RE: Hammond River Holdings Response to Technical Review Committee (TRC)
Questions and Comments – Proposed Upham East Gypsum Quarry, EIA Registration
Document File No. 4561-3-1508

Table 1: Summary of Responses to TRC Questions Regarding the Proposed Upham East Gypsum Quarry, Upham, New Brunswick

CONCEPTUAL SITE LAYOUT PLAN
 FIGURE 2.3.1

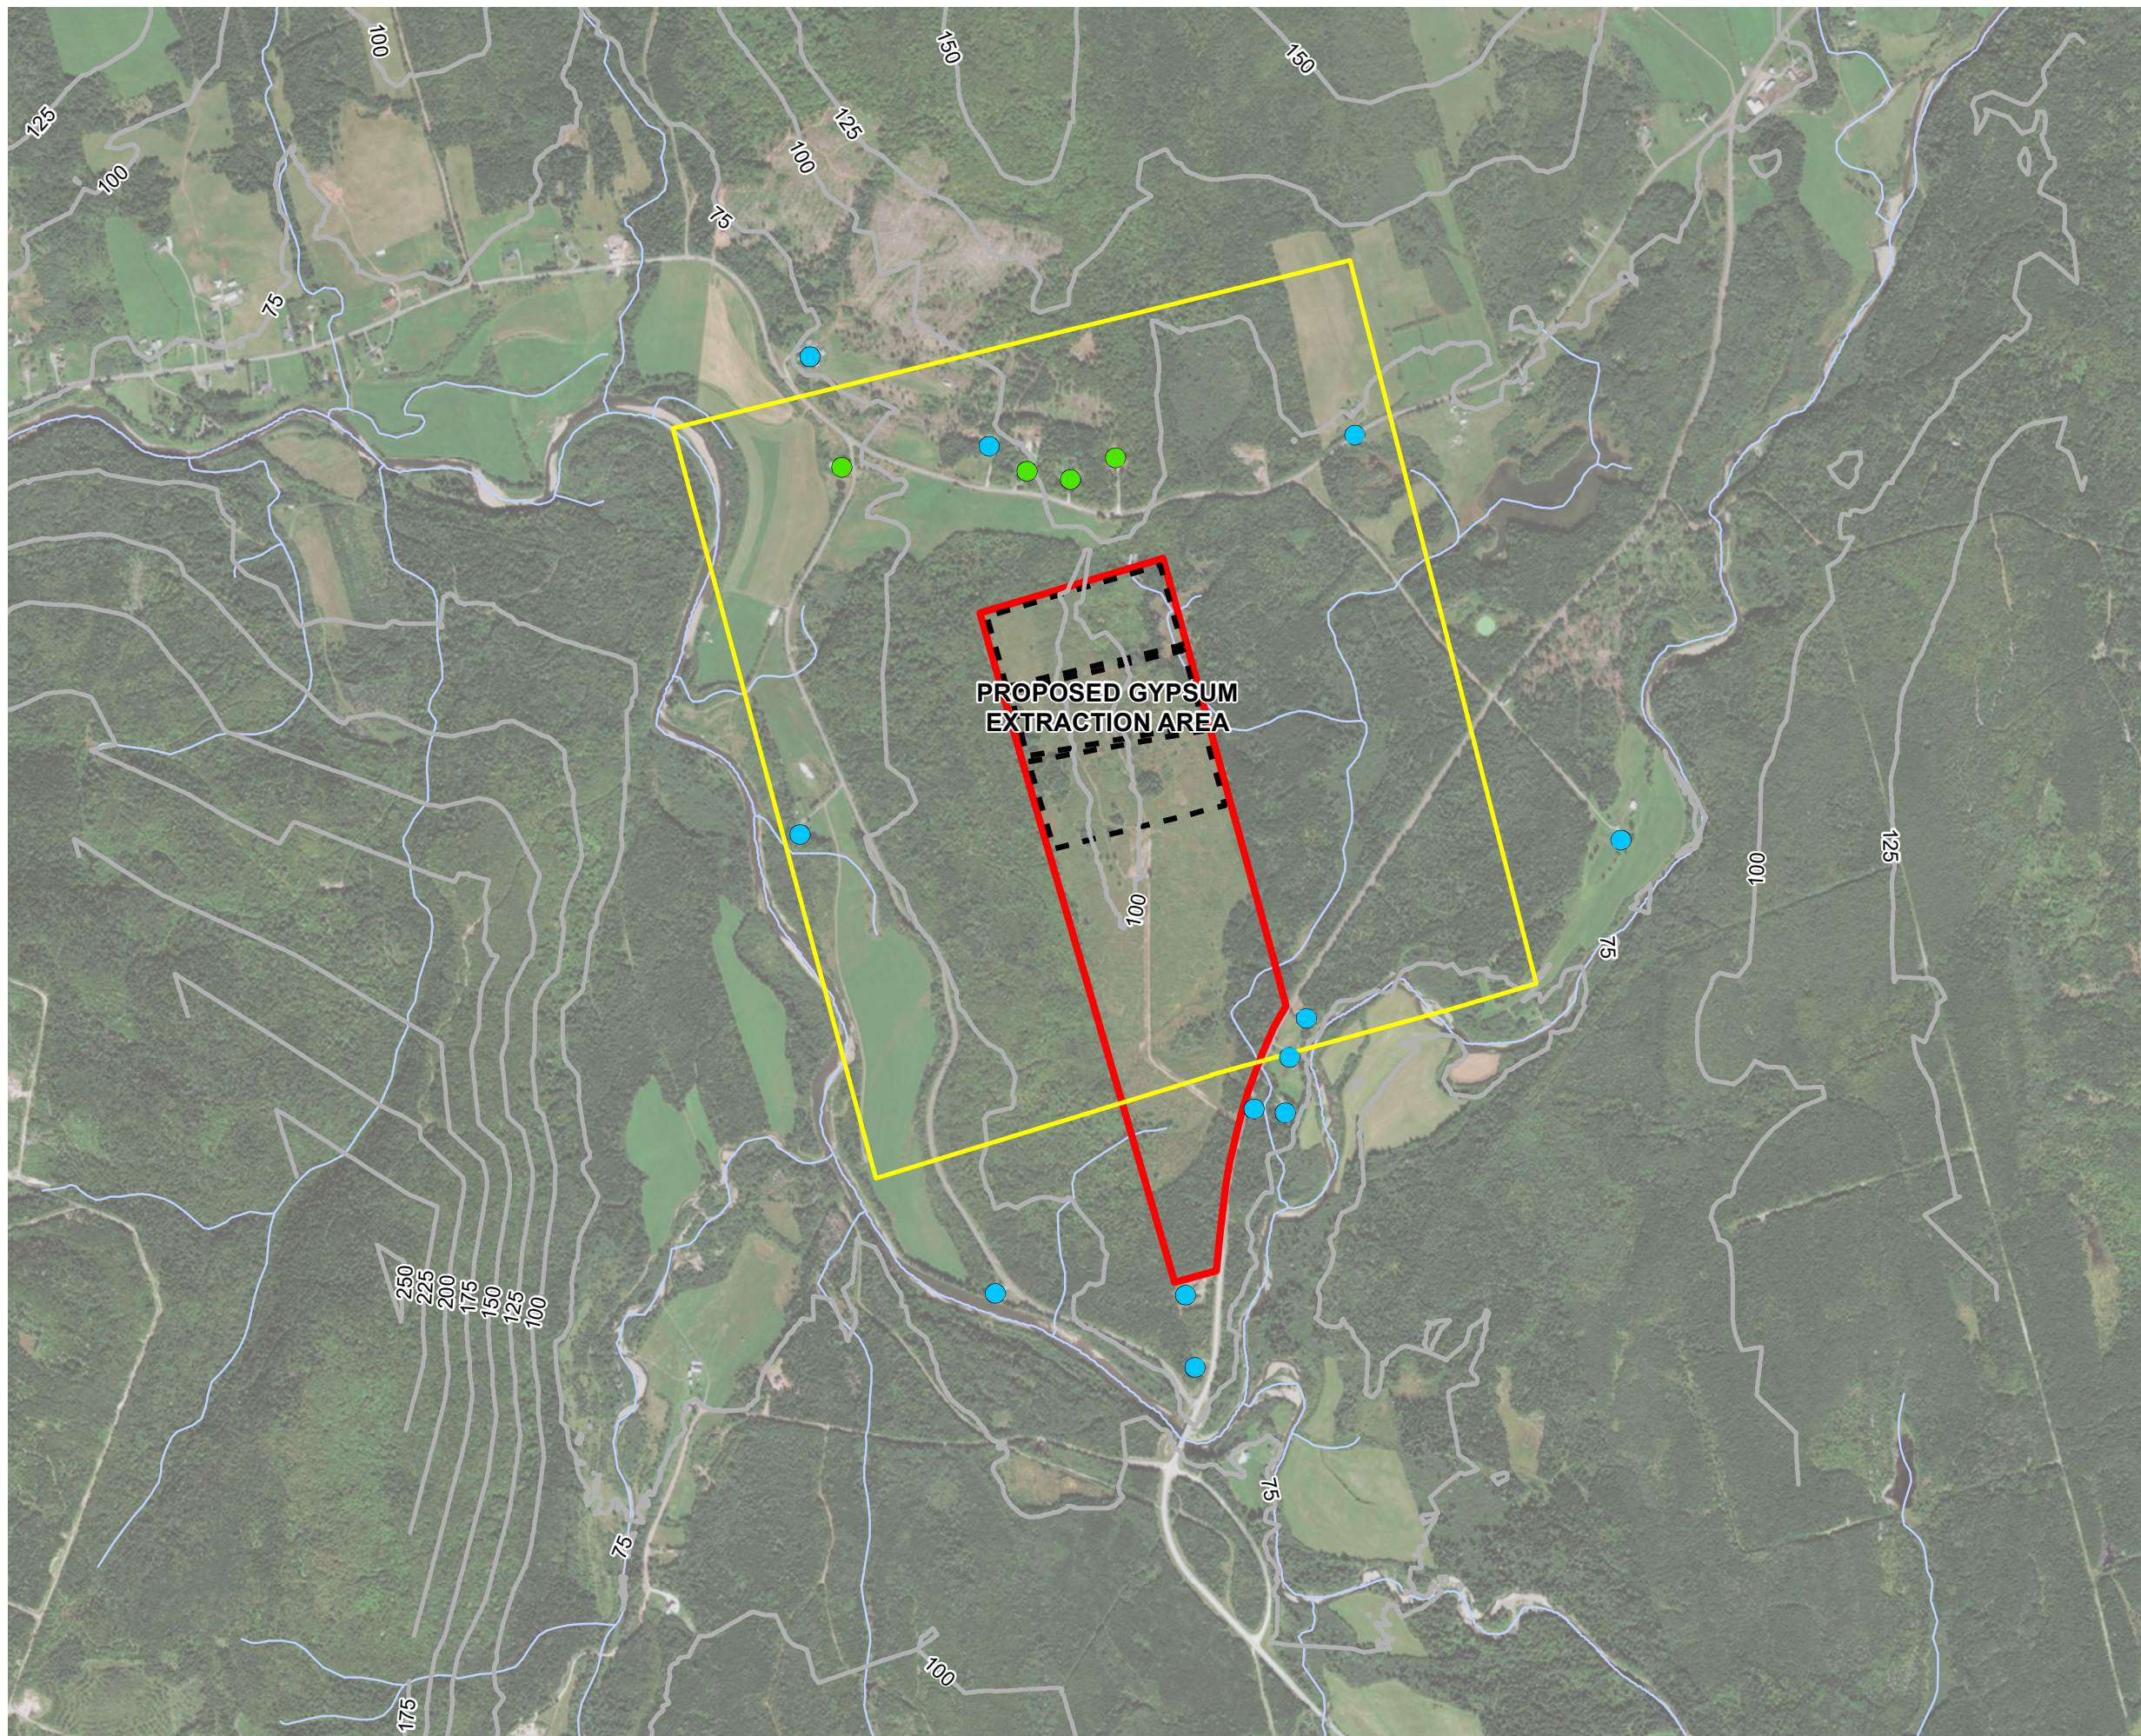
3	In Figure 2.3.1 Conceptual Site Layout Plan (p. 17), can you please clarify the locations of the Gypsum Storage Area and the Topsoil and Overburden Storage Area?	This is a concept that will be refined during the detailed planning stage prior to the quarry becoming operational. To further elaborate on the concept, it is anticipated that the overburden will be used to level an area for the stockpiling of gypsum. Topsoil will be stockpiled separately to preserve it for future reclamation purposes. Surplus overburden materials will be used to progressively slope the final perimeter of the quarry benches to minimize re-handling of materials where appropriate. The goal will be to progressively reclaim areas of the quarry where the resource has been exhausted, while resource extraction is taking place at other areas of the quarry. The final design and management processes for the Project will be provided in the Application for an Approval to Construct for the Project.

Comment/ Question No.	Question/Comment from Technical Review Committee (TRC)	Hammond River Holdings' Response
4	In Figure 2.3.1 Conceptual Site Layout Plan (p. 17), can you please clarify the locations of the Gypsum Storage Area and the Topsoil and Overburden Storage Area?	Question #4 is a duplicate from Question #3 above. Please refer to the response to Question #3 above.
Topic: Groundwater and Surface Water		
5	In Sections 2.3.5 Facilities for Pit Dewatering and Runoff Management (p.19), and 2.4.2.3 Surface Water Management (p.29), given the 10 to 16 m thickness of overburden in the quarry area, and occurrence of wetlands and streams on surface, what is the estimated seepage rates into the quarry? Is the planned area available for water management facilities adequate to handle all site runoff?	<p>Preliminary calculations are as follows. The 100-year, 24-hour total rainfall depth is estimated to be in the order of 177 mm. Assuming an average runoff coefficient of 0.7 (i.e., 70% rainfall flows to settling pond), this would result in a total runoff volume from the entire site of approximately 76,000 m³. Based on the concept of a 6 ha sedimentation pond footprint, the average depth in the pond would be in the order of 1.3 m. This is considered to be a conservative assessment of the storm water management requirements due to the fact that the quarry footprint will be developed in stages and it is anticipated that inactive portions of the site where the resource has become exhausted will be progressively rehabilitated during operations. The size, retention times, and configuration of the settling pond will be refined during the more detailed environmental protection planning phase of the Project.</p> <p>Given what is known from other quarrying sites for gypsum, groundwater seepage into the pit will likely be insignificant relative to the hydrological infiltration of water from rainfall events. Hydrogeological assessments conducted in similar gypsum units located in the Maritimes have concluded that massive gypsum typically has a very low range of permeabilities.</p>

13	In Section 5.4.3.3 Characterization of Residual Effects (p. 98), can you please clarify what the impacts to WC 3 will be? Figure 2.3.1 Conceptual Site Layout Plan (p. 17) seems to indicate minimal disturbance will be required to this watercourse.	The conceptual project layout has been developed to maintain the treed buffer of WC3. Temporary clearing over a small portion of the 30 m buffer may be required to accommodate for installation of a drainage channel, and some erosion control measures may be implemented to WC3 to prevent bank or stream bed erosion arising from the release of settled water from the surface settling pond. Adverse effects to fish and fish habitat in WC3 are not anticipated.

PROPOSED SAMPLE LOCATIONS

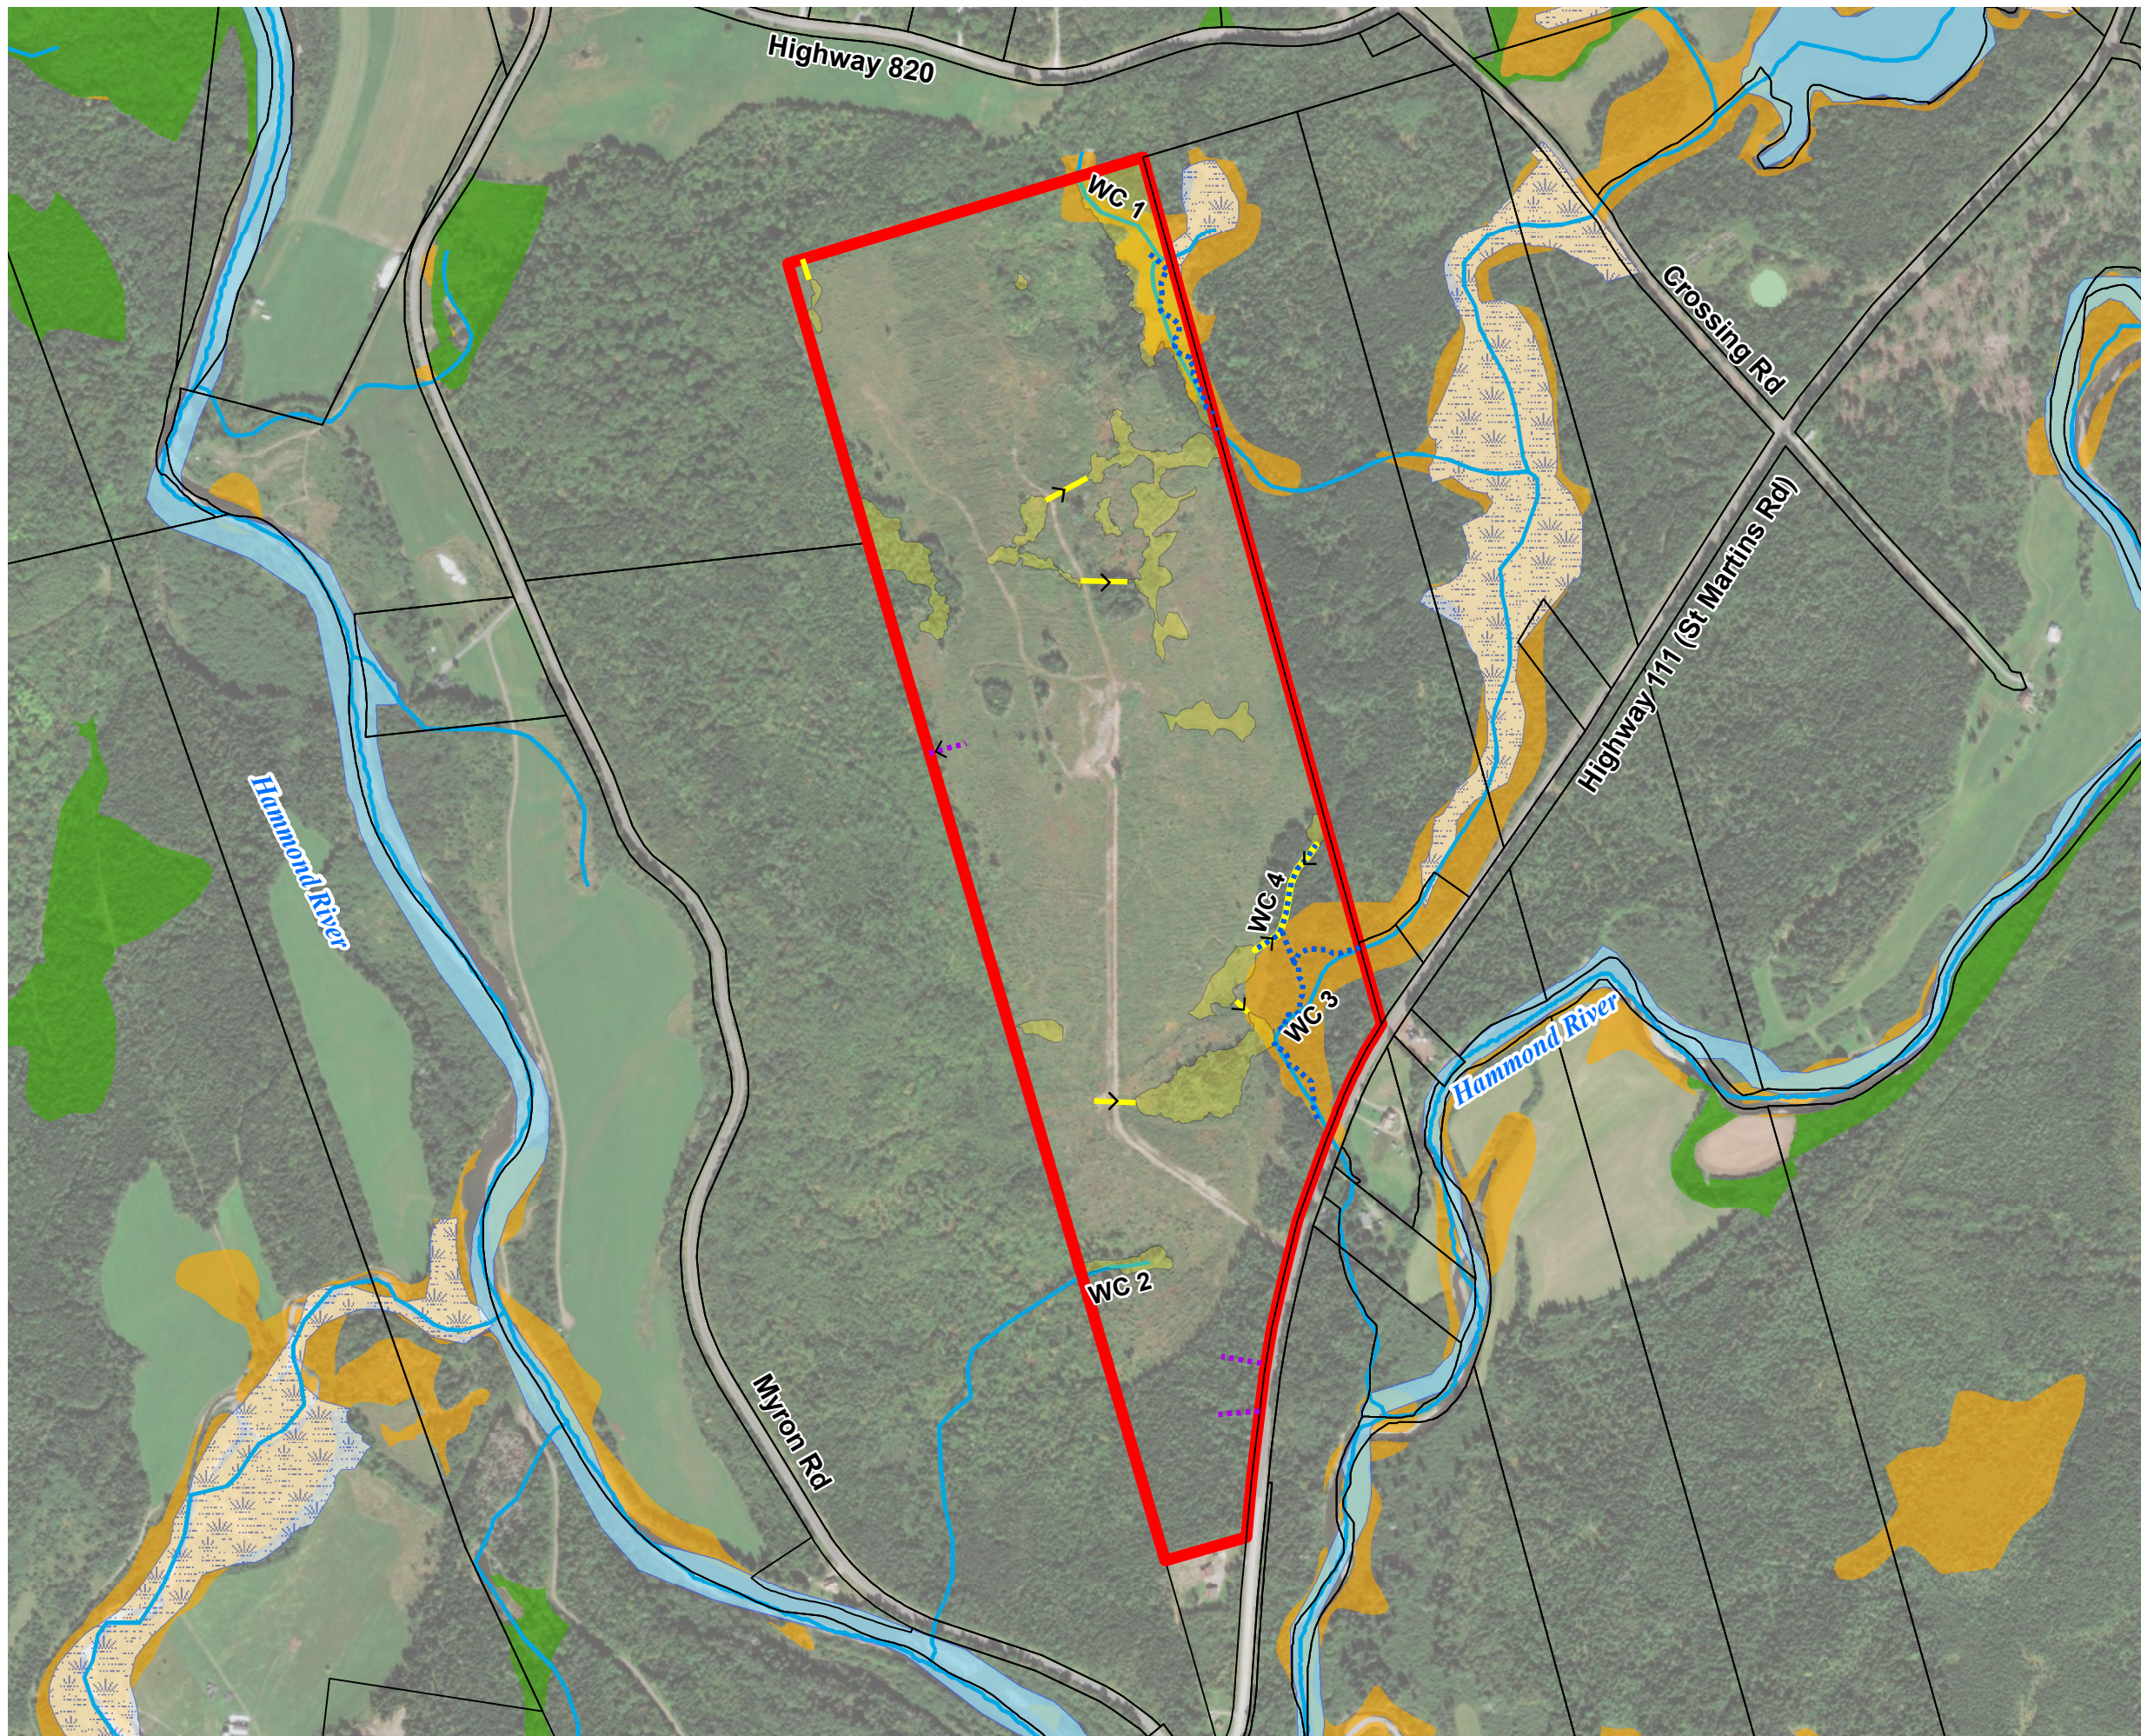
20	<p>In Section 5.3.3.2 of the document, it indicates that up to 20 water wells will be sampled as part of a baseline water quality survey. Can you please show the location of those wells on a map? Please note that the water quality analyses should include, but not necessarily</p>	<p>The baseline water quality survey will be completed for wells within a 2 km radius of the centre of the Project site prior to the commencement of development activities. A more detailed plan, including a map, will be submitted to NBDELG as part of the</p>
